CHECKERS PAARL NORTH

CAPE WINELANDS CYCLING

DISCLAIMER: ROUTE ADAPTION AND SUGGESTIONS. THIS IS NOT FINAL APPROVED INFORMATION – FURTHER SAFETY CONSULTATIONS REQUIRED WITH RELEVANT STAKEHOLDERS.

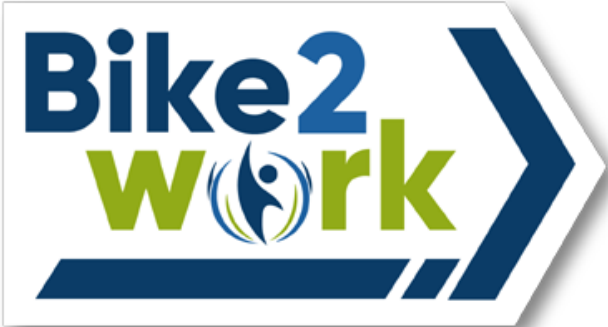
- Suggestion to use Main Rd rather than Berg River Rd. The later route diverts the route away from the school users who would have to cycle back up to Main Rd to get to school. Unless there is some incentive to use this route?
- Push for group starts for school kids on this route (especially as Main Rd is a single carriage way in each direction)
